ADDENDUM

ADDENDUM NO.: 03
PROJECT NAME: WPA Street Reconstruction (E 109th St., S Hoyne Ave., S Harding Ave., E 102nd St.)
PROJECT NO.: 22312, 22313, 22314, and 22329
CONTRACT NO.: C1616
DATE OF ISSUE: December 2, 2024

NOTICE OF CHANGES, MODIFICATIONS, OR CLARIFICATIONS TO CONTRACT DOCUMENTS

F.A. RTE.	SECTION	COUNTY	TOTAL SHEETS	SHEET NO.
			31	31A
CONTRACT NO. C1616				
ILLINOIS FED. AID PROJECT

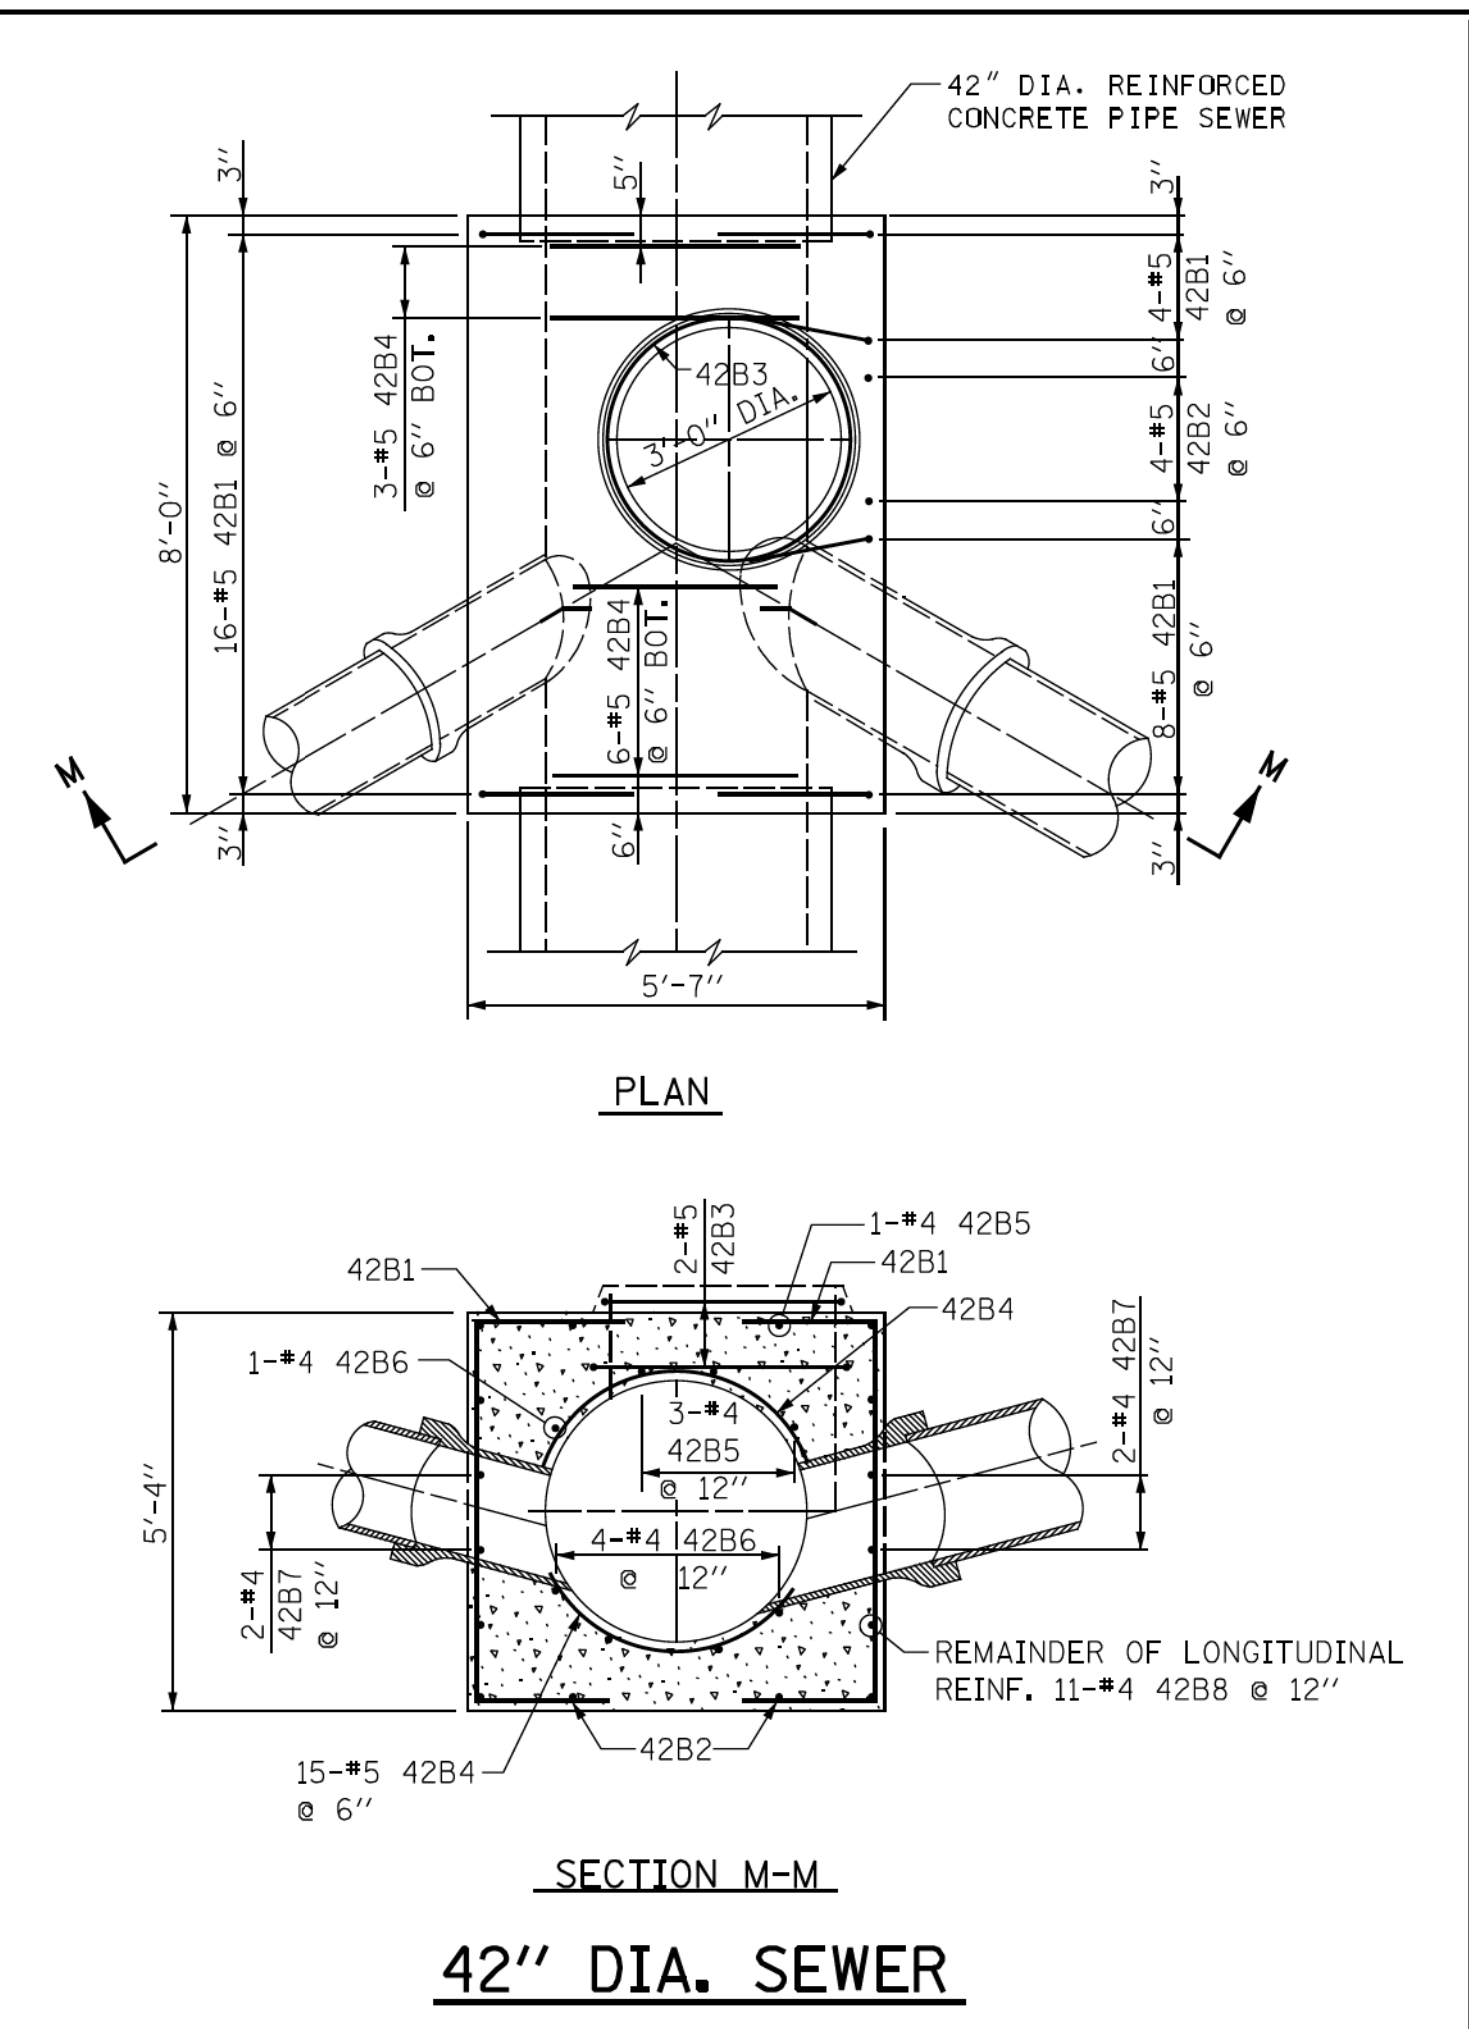
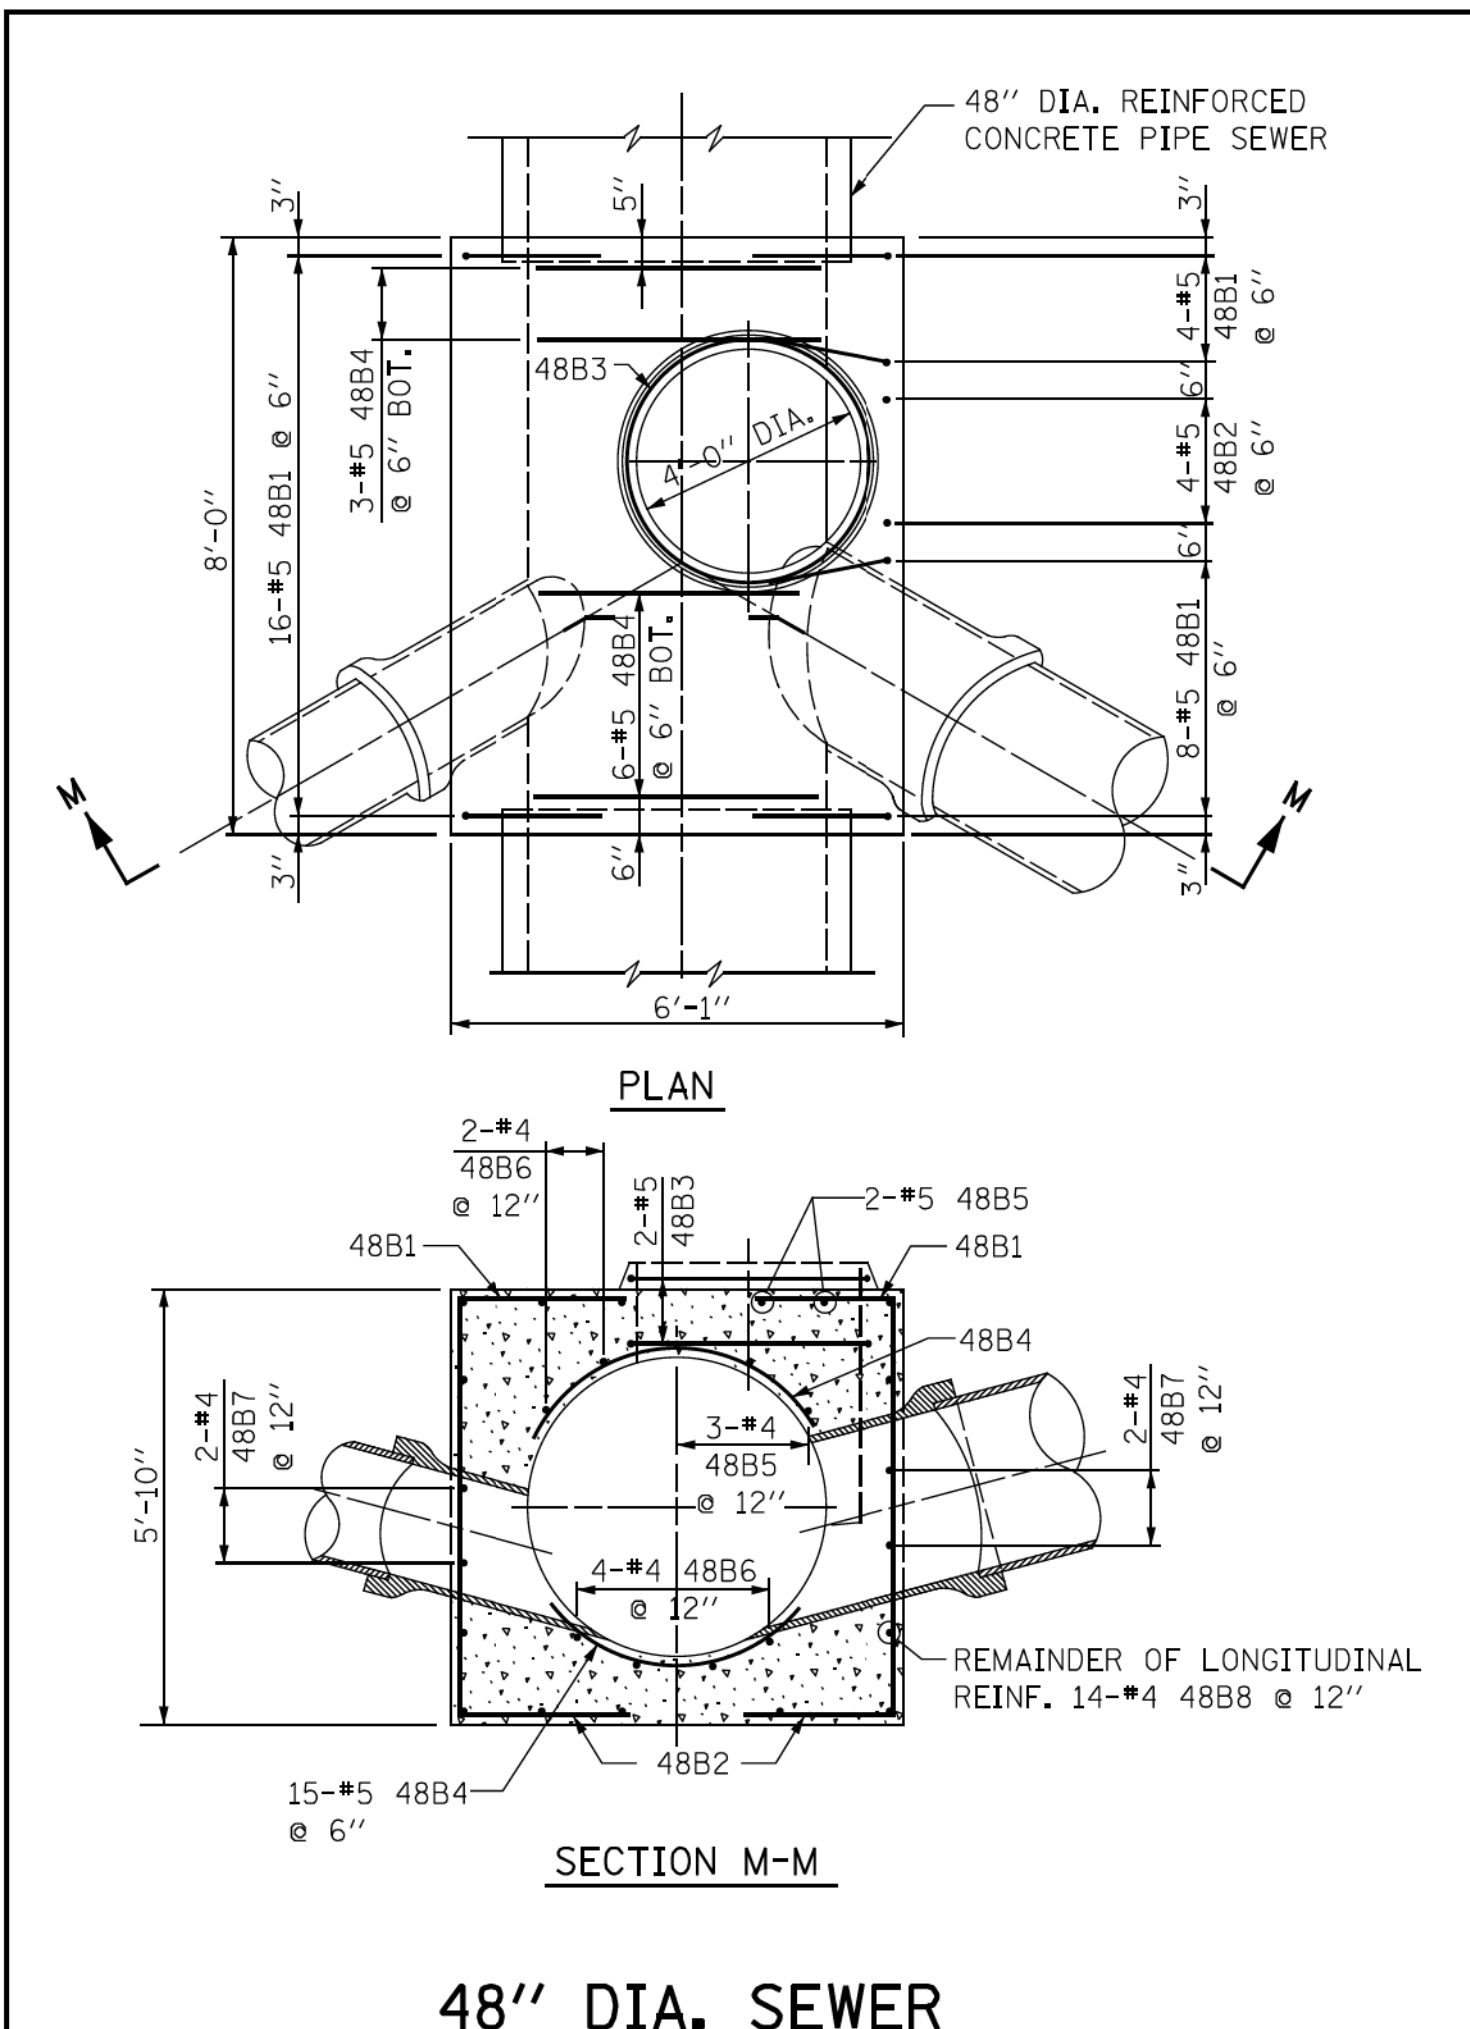
Change 4 ADD SHEET 31B CDWM Sewer Detail for E. 102nd
